# 2020 Corvette: GM TechLink: Removal of Corvette Z51 Spoiler

## Removal of Corvette Z51 Spoiler

GM TechLink

**Fig. 15**

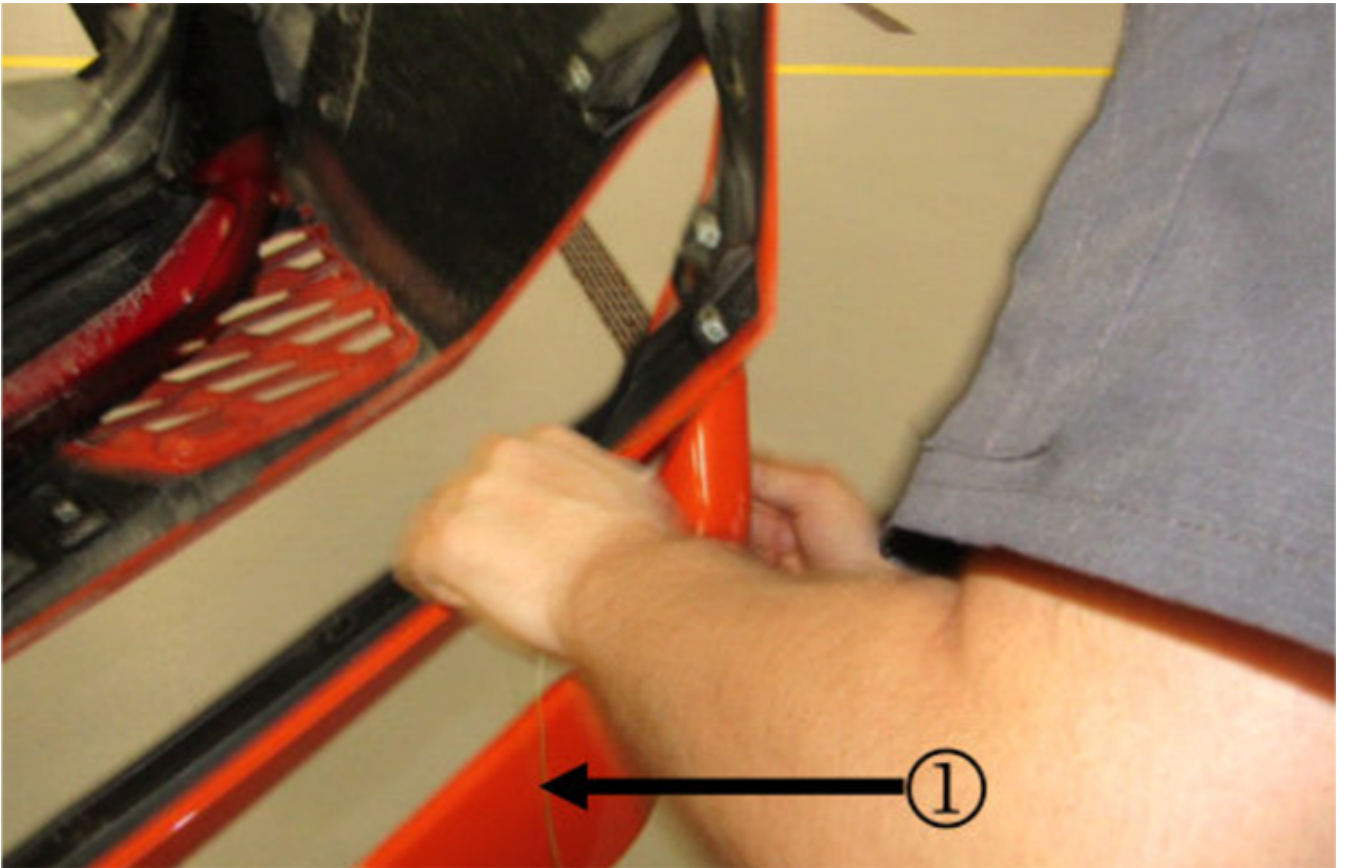
2020 Corvette Stingray models equipped with the Z51 Performance Package feature a rear spoiler that adds downforce to improve high-speed stability. (Fig. 15) If the Z51 spoiler is to be replaced with the high wing accessory spoiler, there may be some concern about applying heat to soften the two-way tape retaining the spoiler without damaging the rear fascia paint. The fascia paint may not be able to withstand high heat generated by a heat gun.

**Fig. 16**

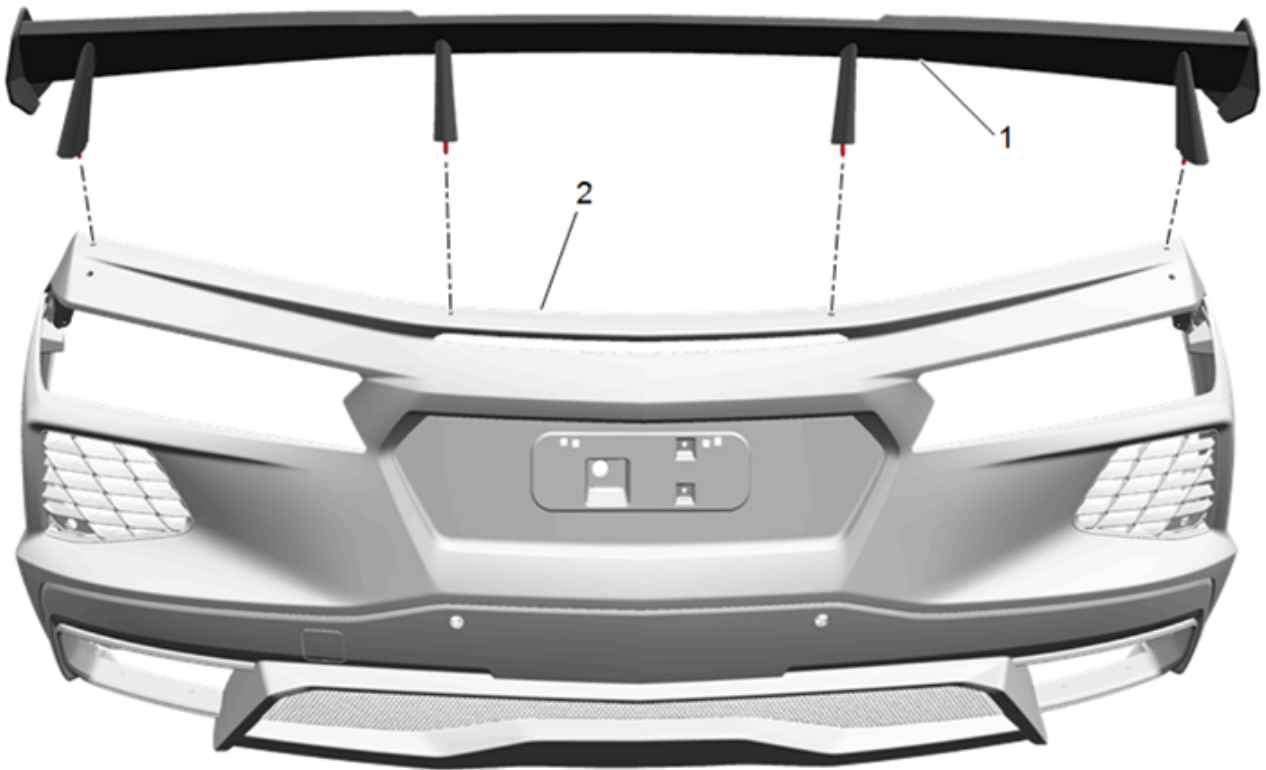
To remove the Z51 rear spoiler, it's recommended to use 50 lb. test monofilament fishing line. Position the line (Fig. 16, #1) between the spoiler and fascia and, with a sawing motion, move the fishing line through the two-way tape to remove the spoiler. Using the fishing line method will eliminate any possibility of damage to the painted fascia surface.

Do not use a heat gun, or attempt to pry the spoiler off the fascia with a plastic, metal or wood trim removal tool, in order to loosen the adhesive tape.

The installation instructions for Rear End Spoiler Package Installation (Fig. 17) in the Accessories Manual in the Service Information have been updated to eliminate the use of a heat gun to soften the two-way tape. Follow the updated installation instructions and do not use a heat gun during the removal process.
